PLANNING MANAGER DECISION

DATE: June 25, 2020

FILE NO.: WAP-20-01/WRG-20-01/MIS-20-01/LLA-20-01

REQUEST: Request for a Water Resource Area permit, a Willamette River Greenway permit, and a Flood Management Area permit to construct a new single-family home on Tax Lot 802 of Clackamas County Assessor Map 31E 02AC. The request also includes a Property Line Adjustment between Tax Lots 802 and 800 of Clackamas County Assessor Map 31E 02AC.

P03

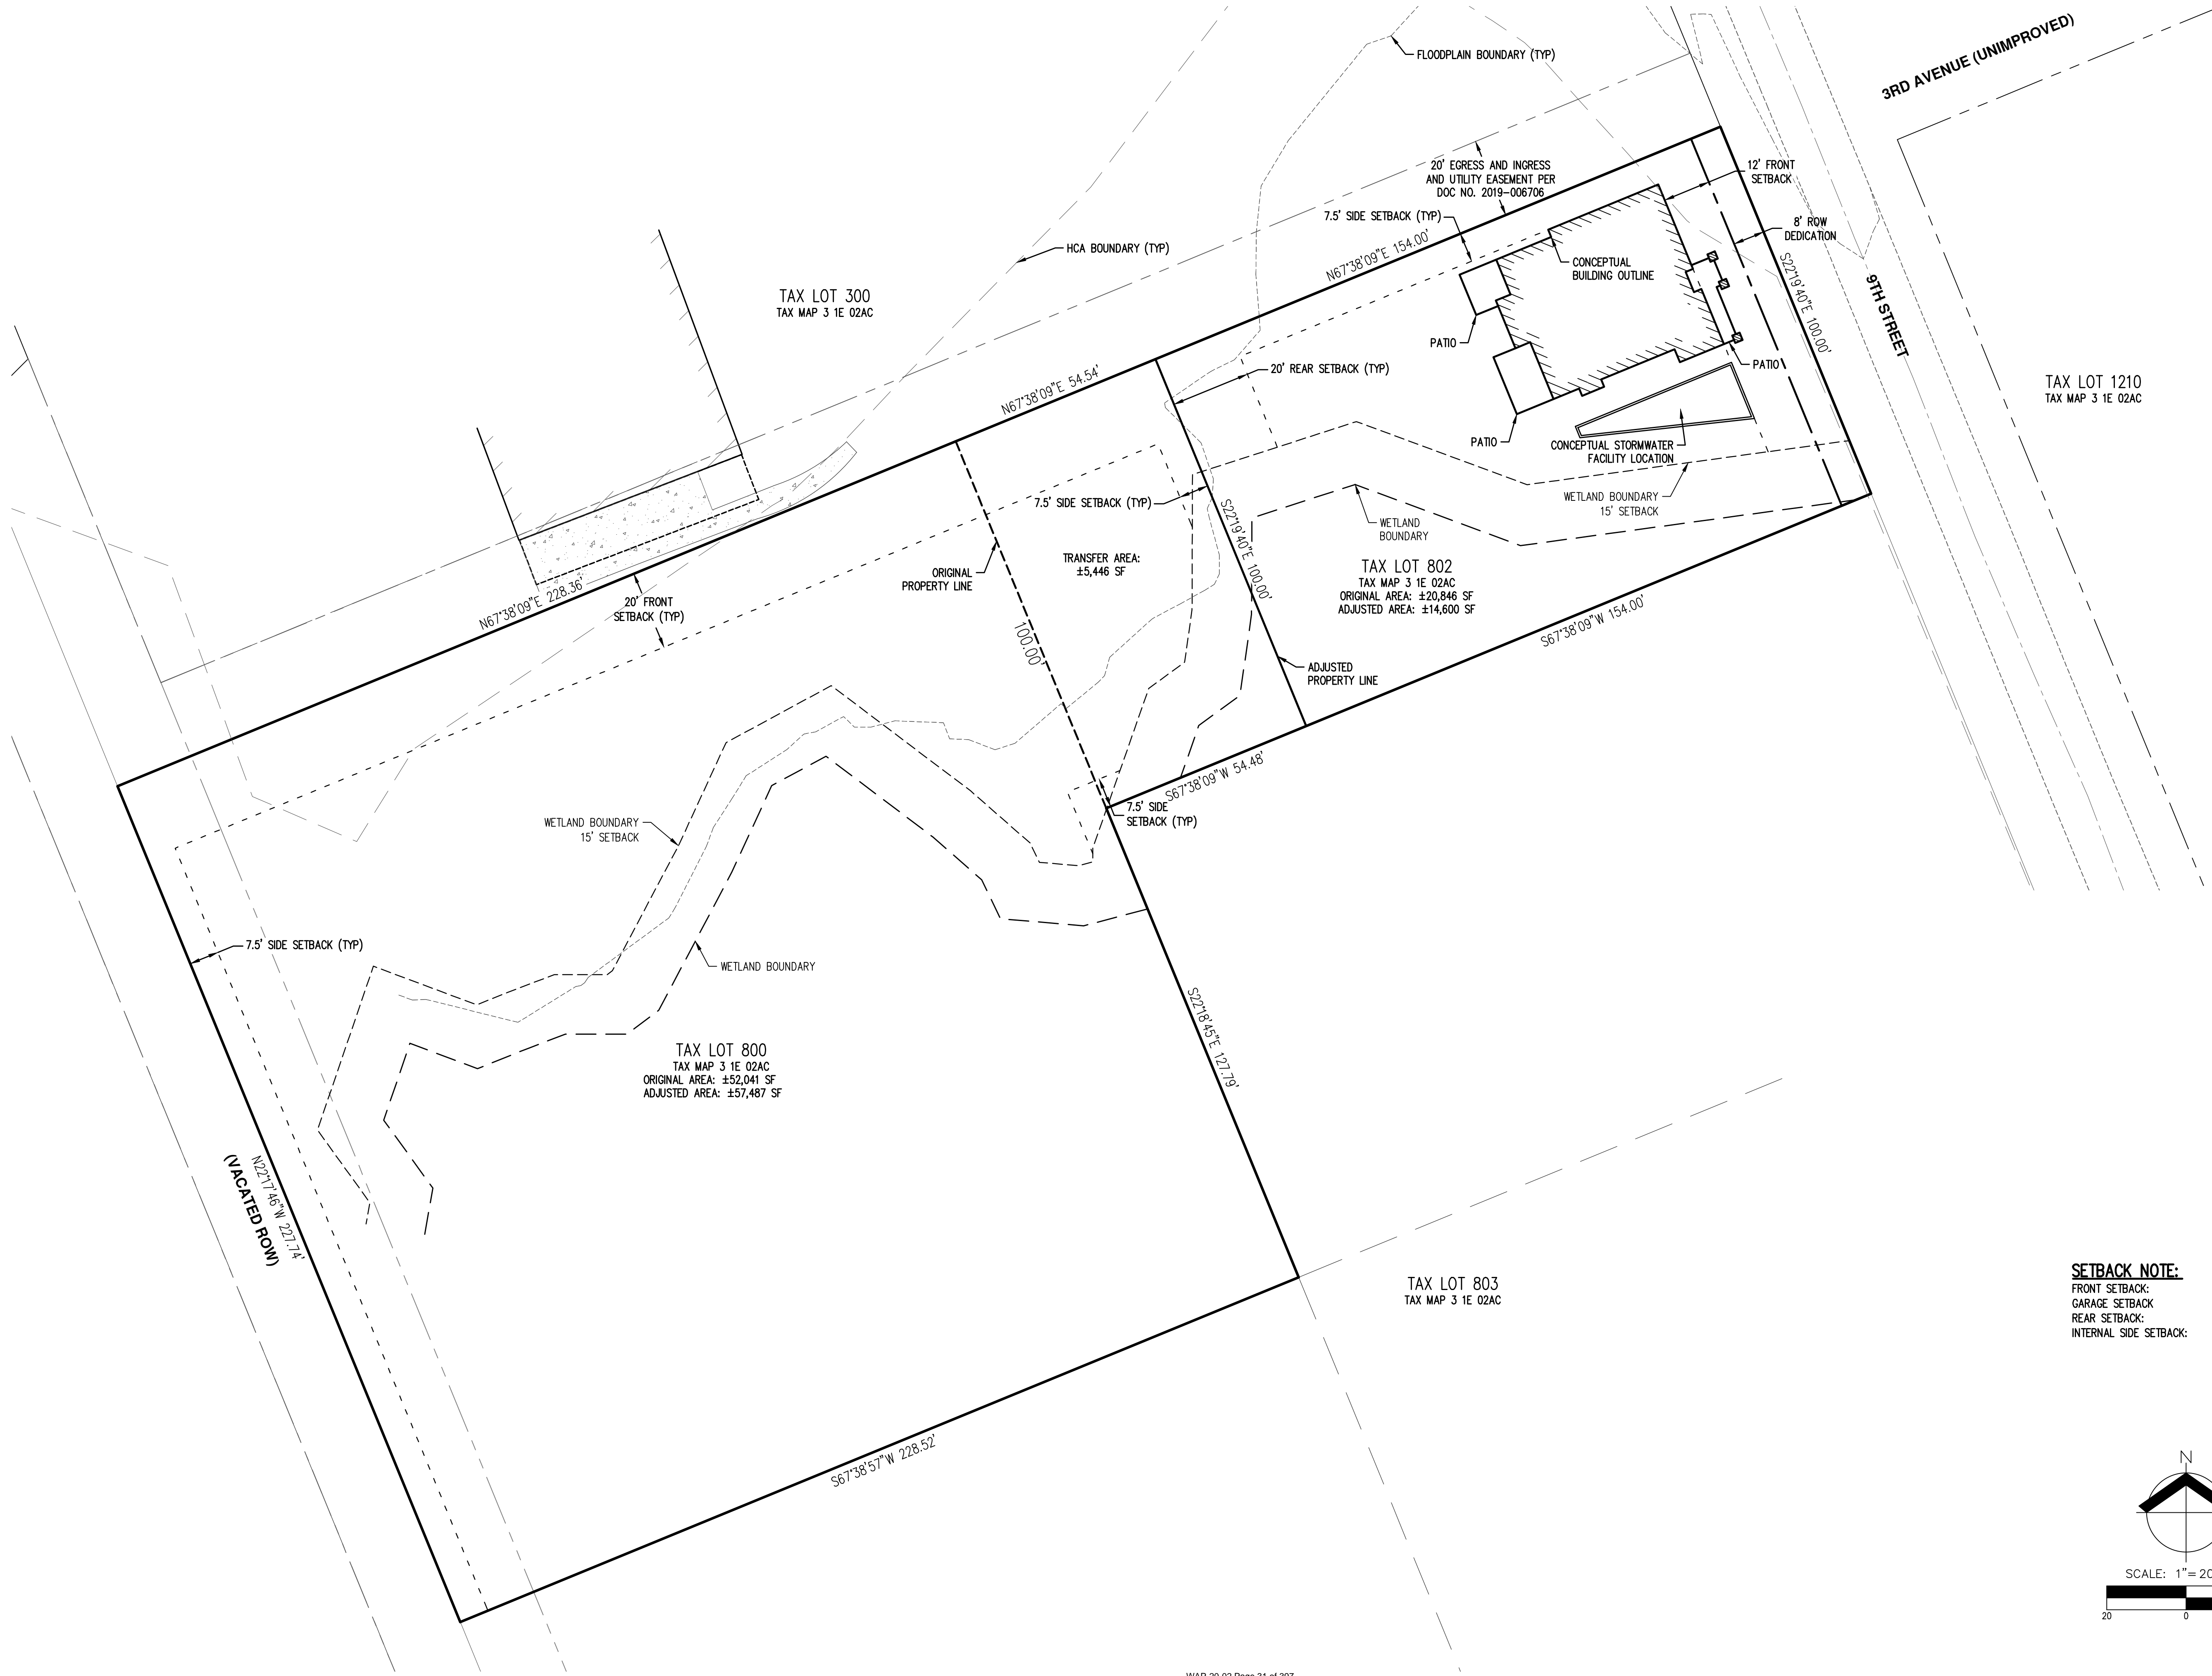
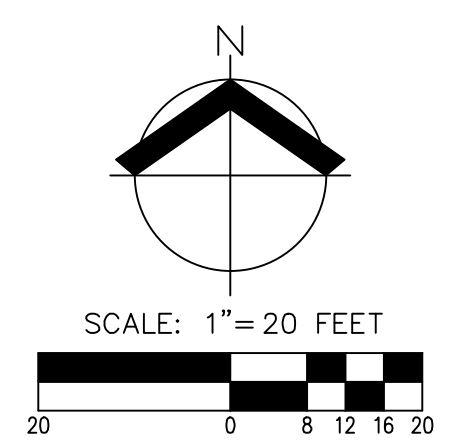
Staff Finding 33: The applicant has proposed greater than 15 feet for the setback from the delineated wetland as shown on Plan Sheet P03. The criteria are met.

CONSTRUCTION MANAGEMENT PLAN
9TH STREET
CONSOLIDATED LAND USE APPLICATION
 WEST LINN, OREGON (TAX LOT 802 TAX MAP 3 1E 2AC)

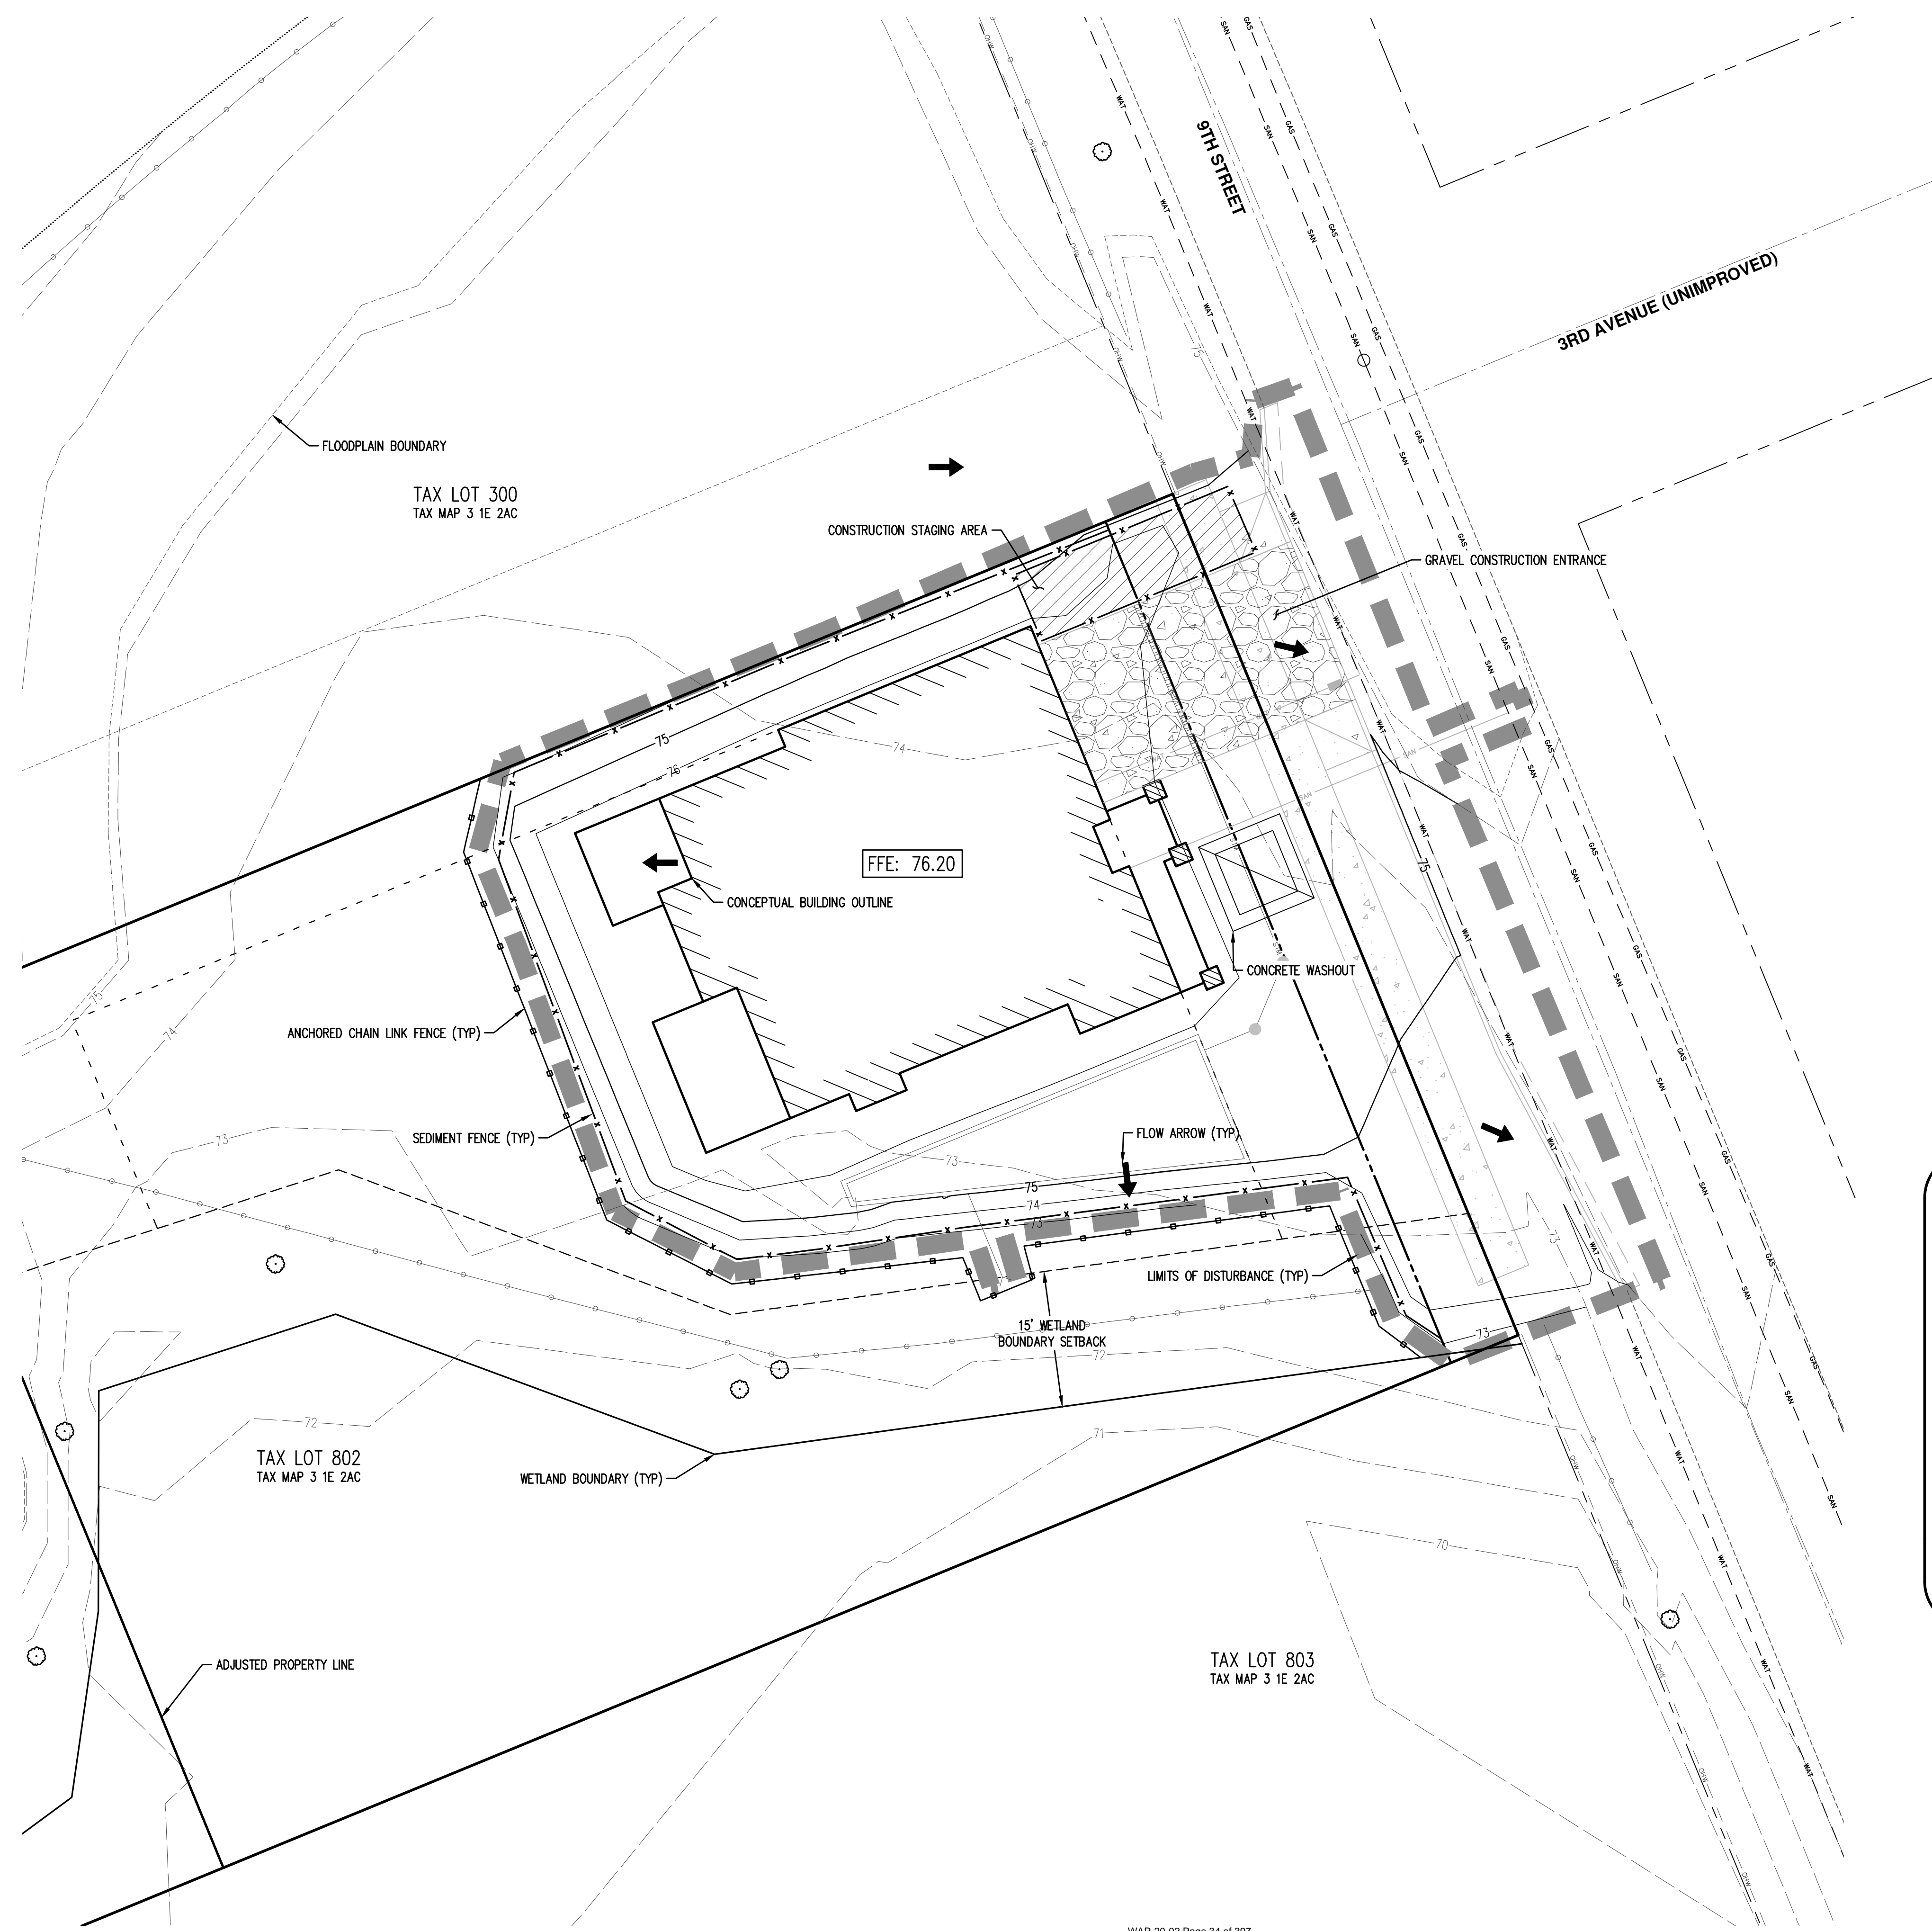
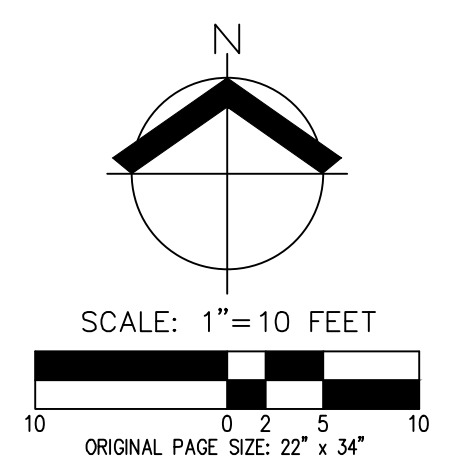
Response: The revised Construction Management Plan included as Attachment C, Sheet P06, illustrates the anchored chain link fence around the WRA. This criterion is met.
